# Town of Franklin

## Planning Board

July 13, 2020

Re: Request for Final Certificate of Completion  
300 Financial Park – Warehouse Development (the Project)  
431 Washington Street, Franklin, MA

**RETAINING WALL #1**  
SOUTH/EAST ELEVATION PROFILE  
Horizontal Scale: 1" = 40'  
Vertical Scale: 1" = 4'

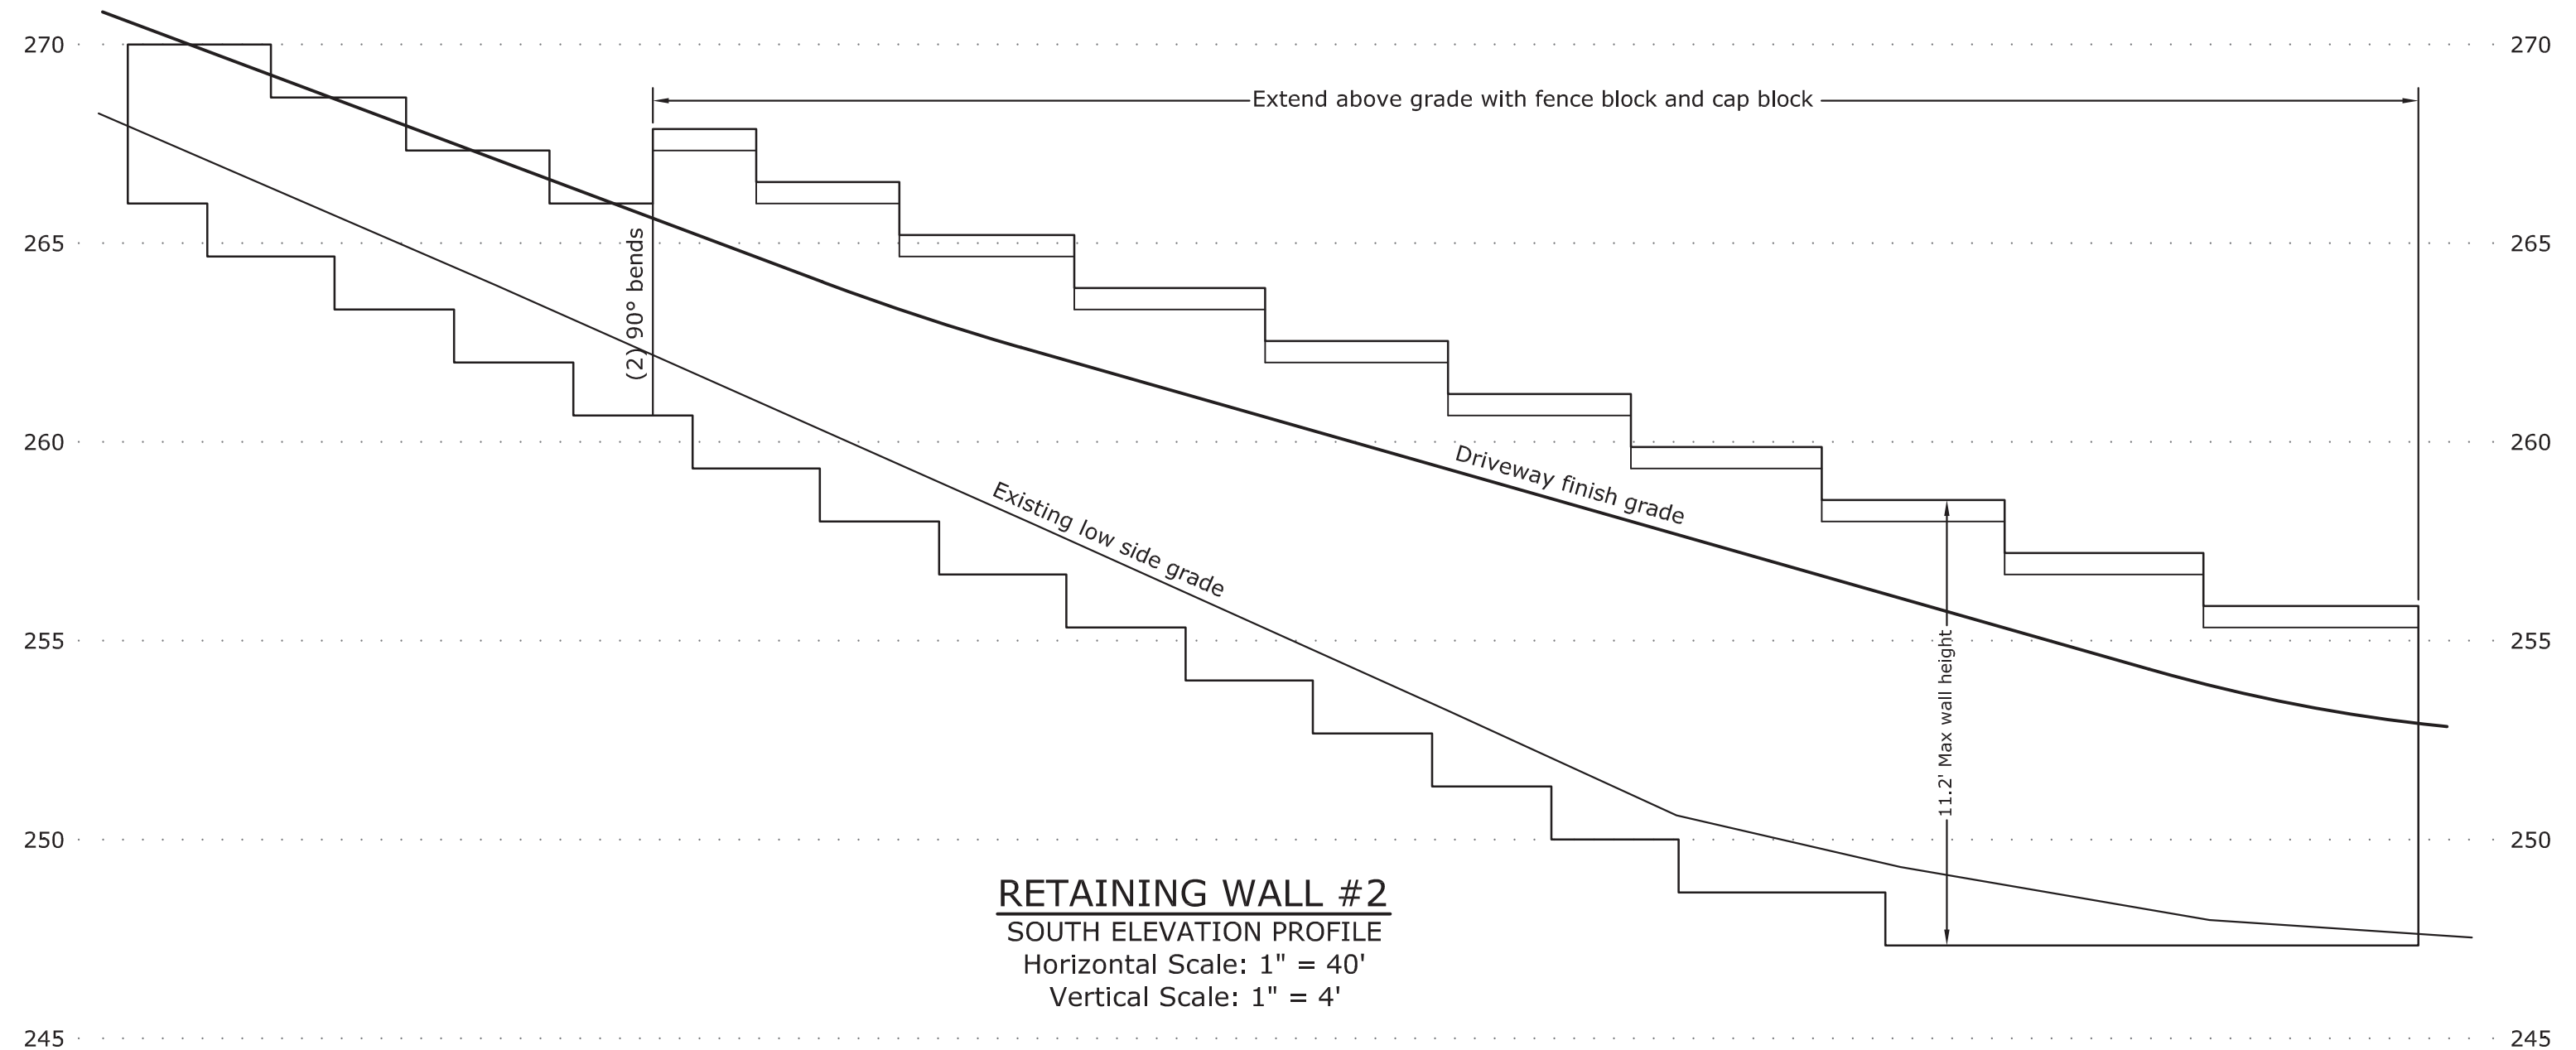
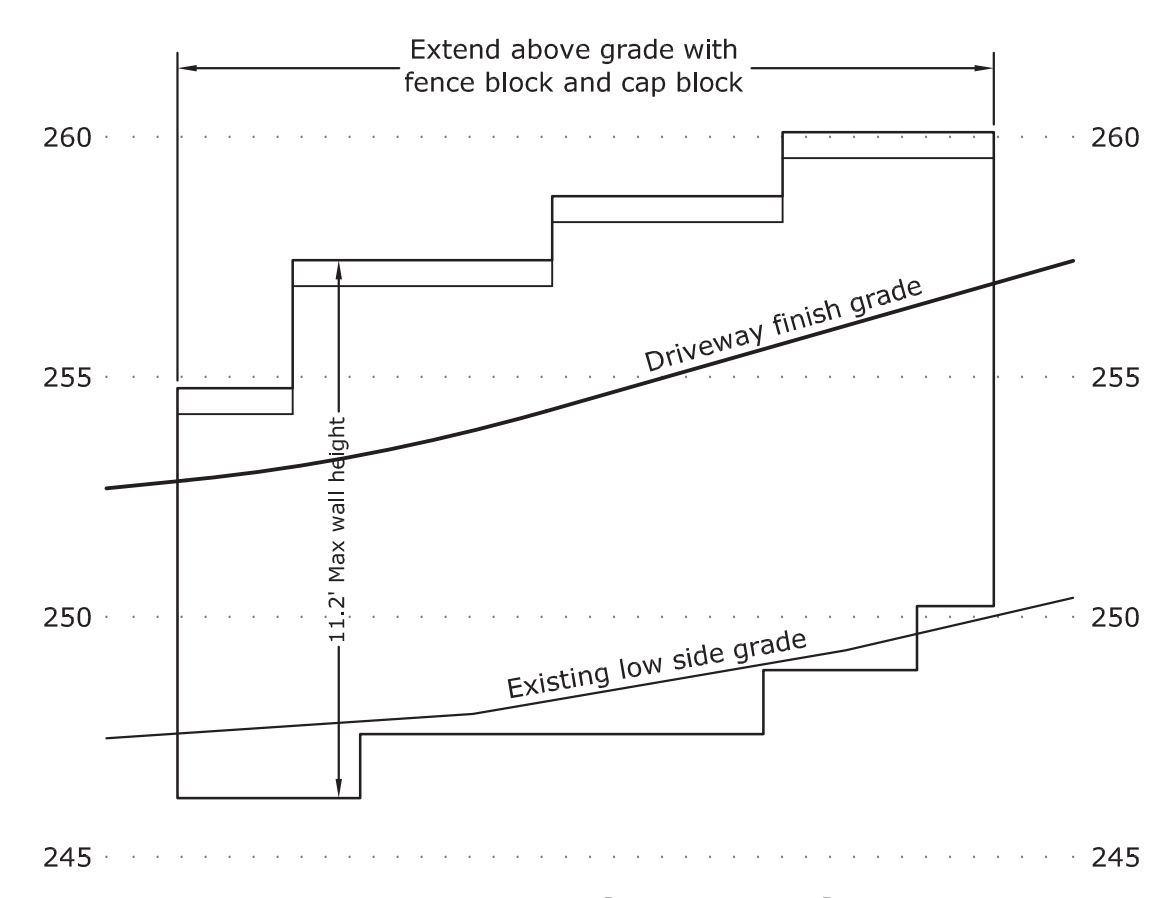
*G7. Provide top and bottom elevations for all retaining walls. PLT: The retaining wall elevations and details will be shown on a revised set of plans. Please note that the Applicant proposes fencing along all proposed retaining walls. Moreover, all retaining walls require building permits, which will address the heights and structural requirements. **BETA2: Issue remains outstanding.** LPI: General details and elevations of the 3 proposed retaining walls have been added to sheet 16 of the plans. The specifics of the structural design and details will be provided by others as part of the building permit application for the retaining walls. **BETA3: Information provided. BETA notes that due to height of the walls (>10 feet) structural design and permitting through the building department will be required prior to construction.***

*elevations of the 3 proposed retaining walls have been added to sheet 16 of the plans. The specifics of the structural design and details will be provided by others as part of the building permit application for the retaining walls. BETA3: Information provided. BETA notes that due to height of the walls (>10 feet) structural design and permitting through the building department will be required prior to construction. LPI2: The necessary information will be provided to the Building Department with the application for the required Building Permit. BETA3: Information provided – no further comment.*
